## **MEMORANDUM**

Preliminary Plan of Subdivision - Resubdivision Five (5) One Family Detached Dwelling Units

PROJECT NAME: Fawsett Farms

1-03054

**FAWSETT FARM** Vicinity Map and Neighborhood Delinection

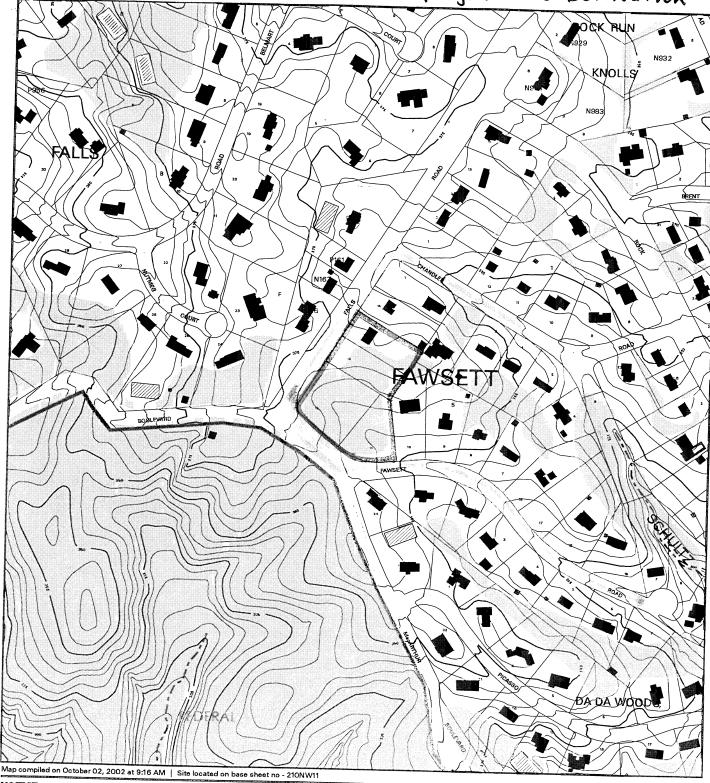
Staff has attached to this Memorandum a Vicinity Map, which delineates the relevant neighborhood for analysis purposes under § 50-29(b)(2). It has been the longstanding practice of the Planning Board to exclude from its defined neighborhood those existing lots that are situated in zones different from the zone in which the property that is the subject of the application is located. Consequently, Staff recommends excluded from its consideration the lots on the west side of Falls Road across from the Site, which, as stated above, are located on RE-2 zoned property. The defined neighborhood, as depicted on the attached neighborhood delineation map, includes the entirety of Block 5. which is bounded by Falls Road to the west, Chandler Road to the north, Fawsett Road and MacArthur Boulevard to the south, and the Schultz Tract to the east. Staff did not include lots outside of Block 5 in the defined neighborhood because most of thoselots are oriented towards other roadways or are outside of the Fawsett Farms subdivision. Staff is of the opinion that the area contained within Block 5 is representative of the lot character and development pattern originally established; and, furthermore, the block has remained virtually unchanged since the initial recordation of the subdivision (see Neighborhood Delineation Map).
